MONTGOMERY COUNTY HISTORIC PRESERVATION COMMISSION
STAFF REPORT

Address:	7120 Maple Ave., Takoma Park	Meeting Date:	7/10/2024
Resource:	Contributing Resource Takoma Park Historic District	Report Date:	7/3/2024
Applicant:	Jessica & Eli Williams-Szenes Brian McCarthy, Architect	Public Notice:	6/26/2024
Review:	HAWP	Tax Credit:	no
Case Number:	1074329	Staff:	Dan Bruechert
Proposal:	Basement Egress Window, Enclosure of Rear Deck, Other Fenestration Alterations

Staff recommends that the Historic Preservation Commission **approve with one condition** the HAWP application:

1 PORCH SECTION
Scale: 1/4" = 1'-0"

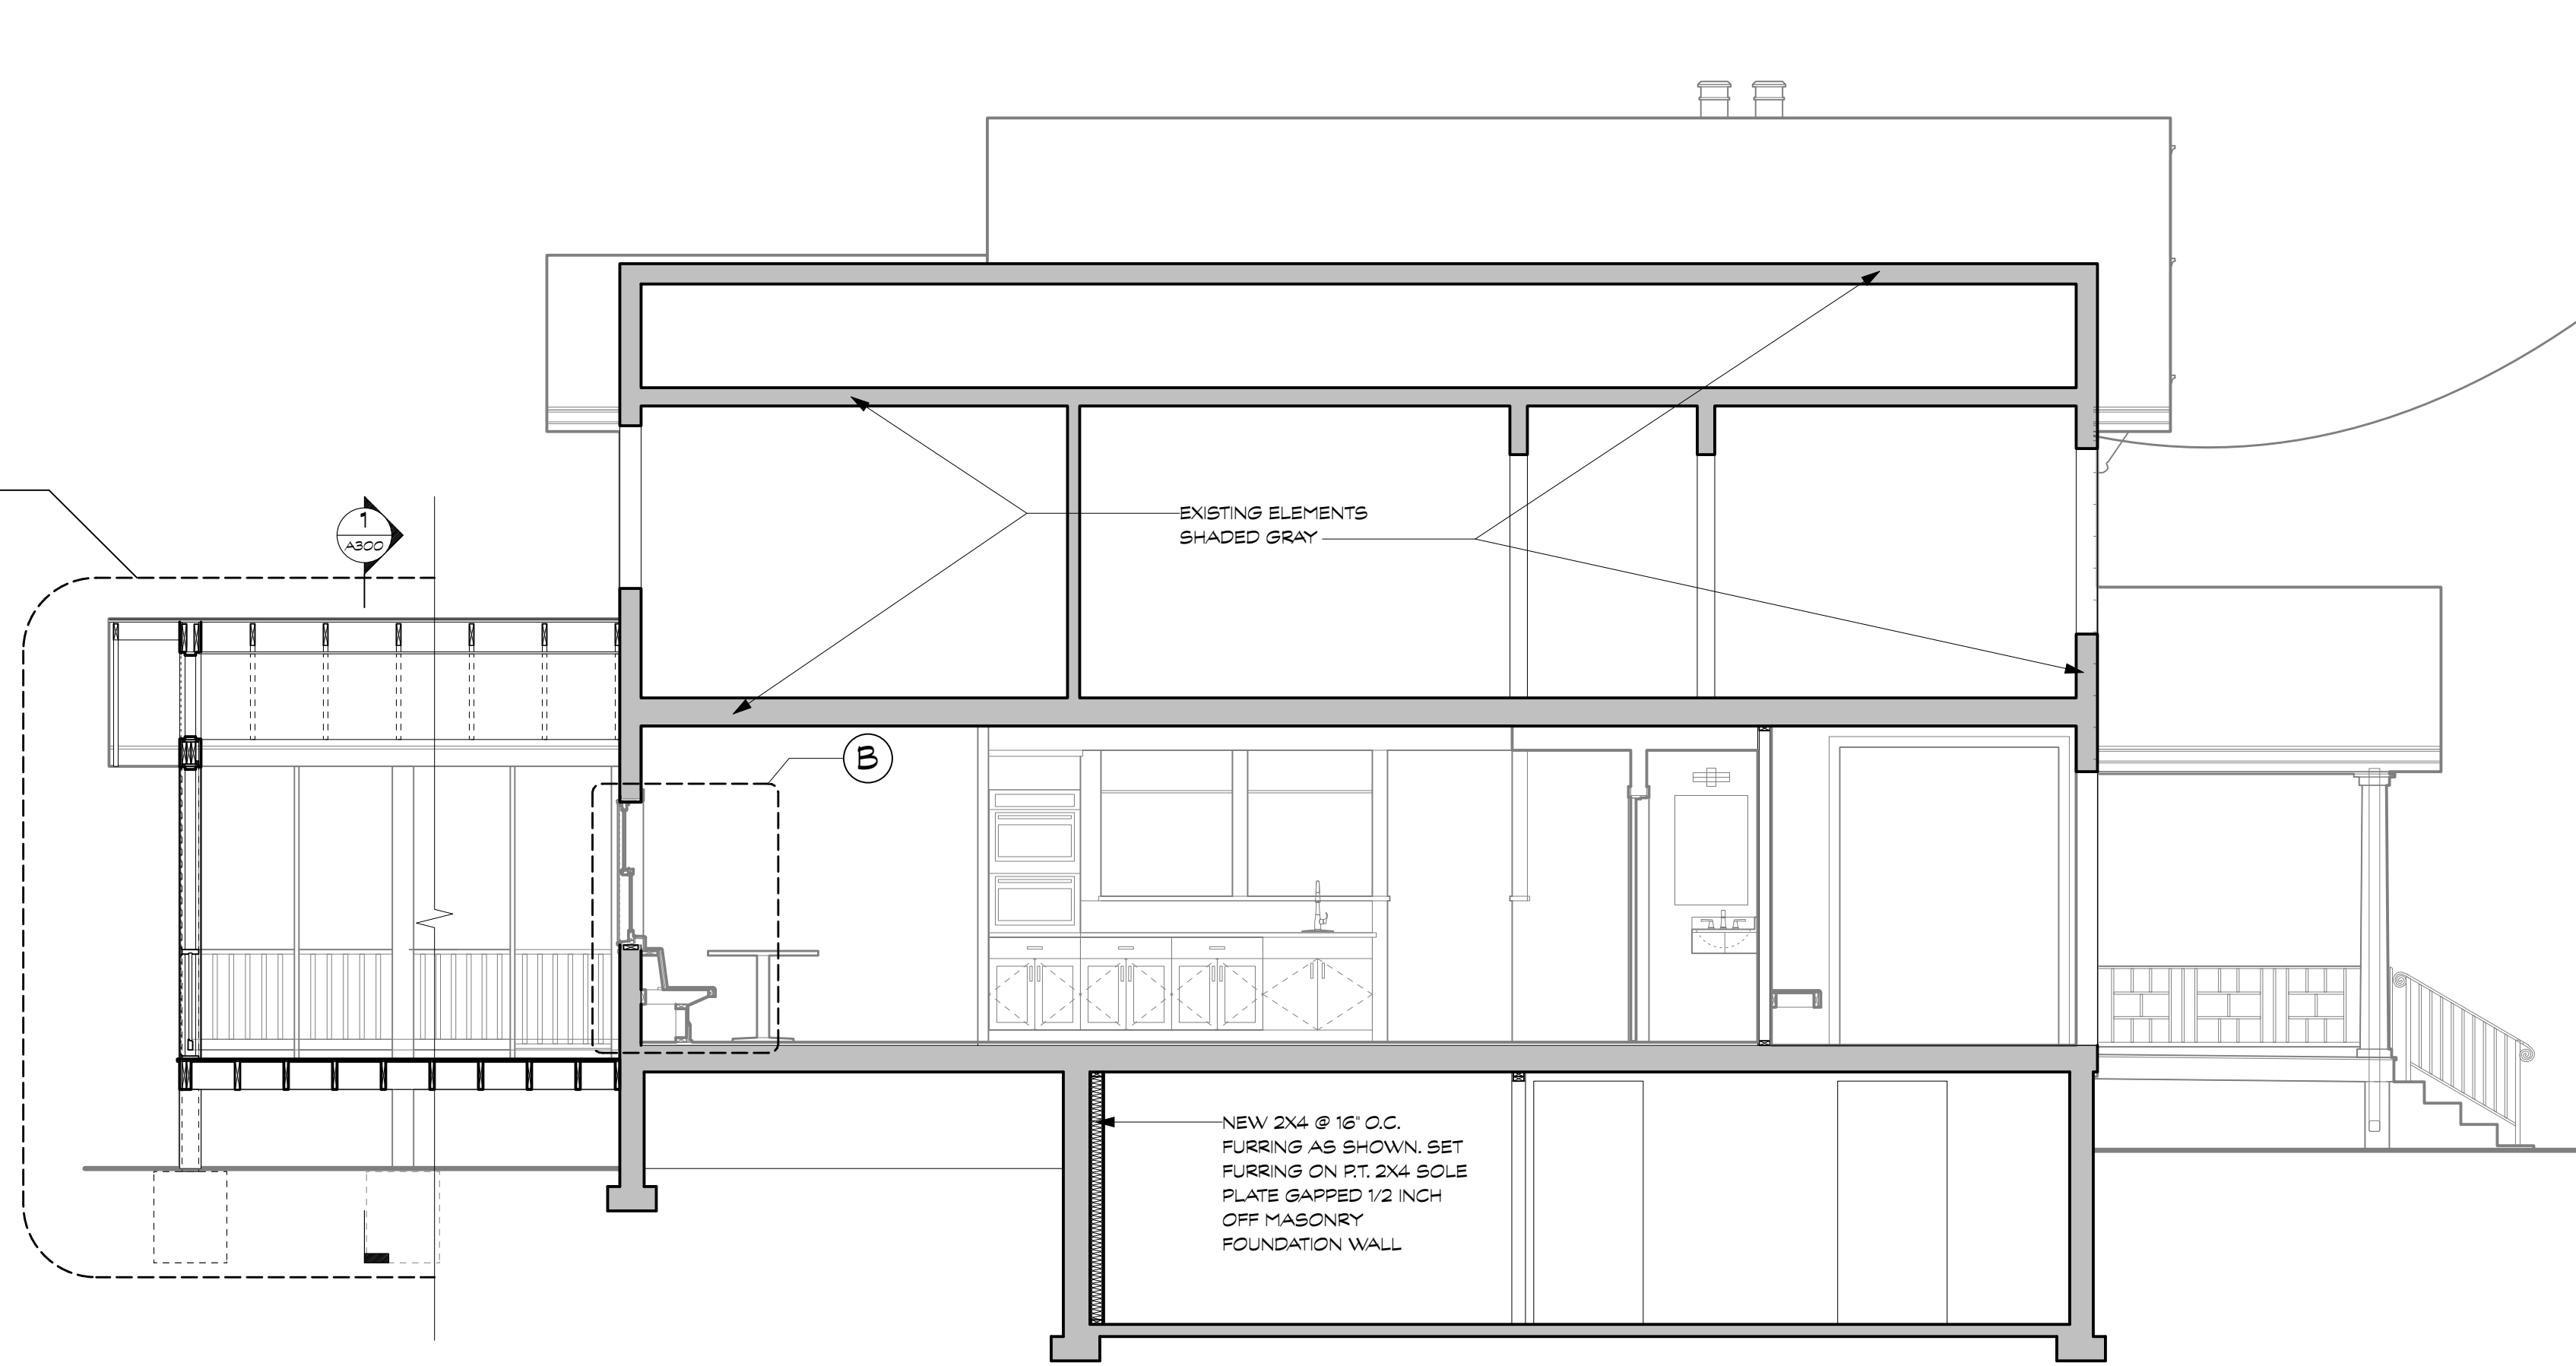
At the rear of the non-historic addition, there is a pressure treated wood deck, measuring approximately 10' × 14' (ten feet deep by fourteen feet wide). The deck has a wood railing and wood stairs. The applicant proposes to demolish this deck and construct a screened-in porch measuring 12' × 14' 5 ½" (twelve feet deep, by fourteen feet, five and one-half inches wide). The porch will be framed in wood, with boral trim, and will match the house roof rake with exposed rafter tails and matching shingles. The deck rails, and framing will be wood. The exterior stairs will be pressure-treated wood. The screen porch flooring will be a composite material.

Staff finds the existing deck is not a historic feature and its removal should be approved as a matter of course.

Staff finds the proposed screened-in porch will not overwhelm the size of the historic house and will not be at all visible from the public right-of-way. Staff finds the design details are consistent with the house's Craftsman architecture. Staff additionally finds the framing, trim, railing, and roofing are all consistent with the character of the house and surrounding district. The final material under consideration is the proposed 'synthetic composite PVC' porch flooring. Staff finds that the recently adopted Policy No. 24-01 allows substitute materials for a rear porch on a Contributing Resource that is not visible from the public right-of-way. However, a material specification was not provided with the application materials. Staff recommends the HPC include a condition for the approval to this HAWP that requires a material specification for the rear porch flooring, with final approval authority delegated to Staff. With the recommended condition, Staff finds the proposed porch is consistent with 24A-(b)(2) and (d); the *Design Guidelines*; Standards 2, 9, and 10; and HPC Policy 24-01.

1. Final material specification for the porch flooring must be submitted to Staff for review and approval with final approval authority is to delegated to Staff before final approval documents can be issued.

A EGRESS WINDOW WELL
Scale: 3/4" = 1'-0"

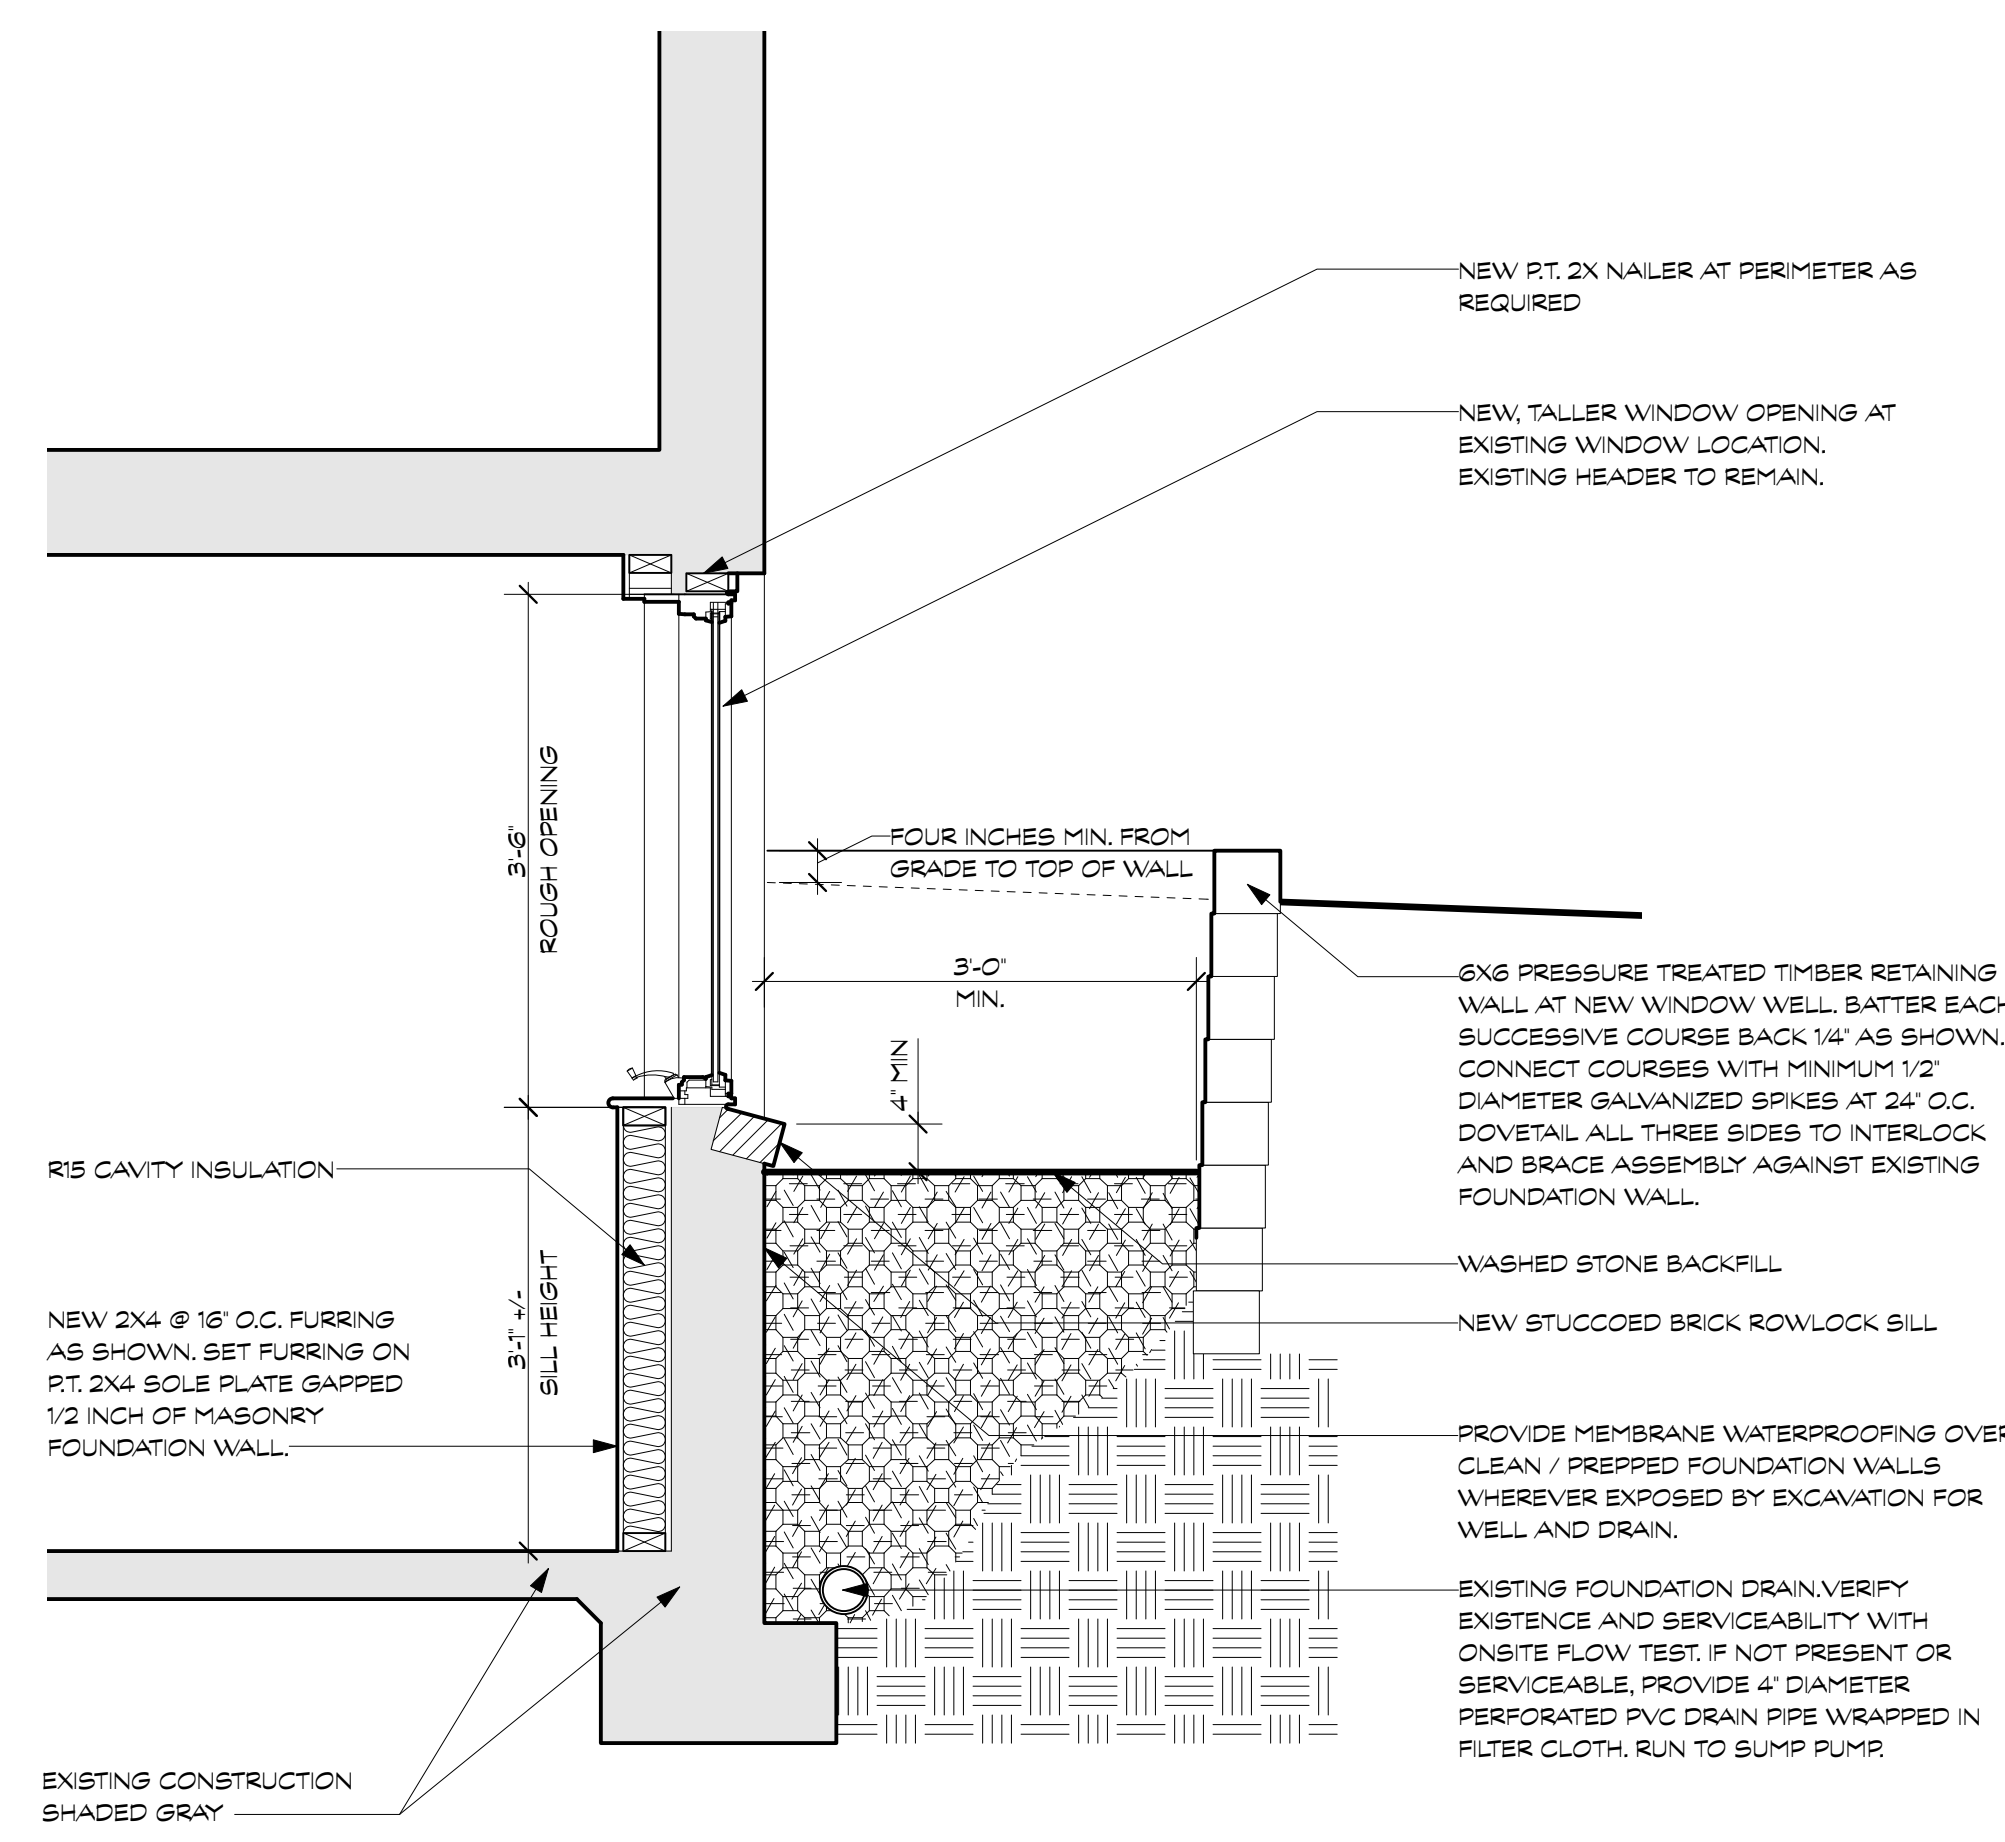
On the left elevation, towards the rear, there is a basement window that was filled in with glass block. The applicant proposes to remove the glass block, enlarge the opening, and install a six-light, aluminum-clad casement window that satisfies egress requirements. A pressure-treated timber retaining window well will be installed around the window opening.

Staff finds that while the proposed window will be partially visible along the driveway, its installation will not have a significant impact on the character of the house or surrounding streetscape because it is so far from the front wall plane. Staff additionally finds the design and material of the proposed window is appropriate for the character of the house and surrounding district and recommends the HPC approve the new egress window under 24A-8(b)(2) and (d); the *Design Guidelines*, and Standards 2, 9, and 10.

Finally, Staff finds the proposed timber window well will not have a significant impact on the character of the house and only the top 4" (four inches) or so will be above grade. This feature will not be visible until you are adjacent to it. Staff finds the proposed window well will have no material effect on the character of the house and recommends the HPC approve it under 24A-8(b)(2) and (d); the *Design Guidelines*, and Standards 2, 9, and 10.
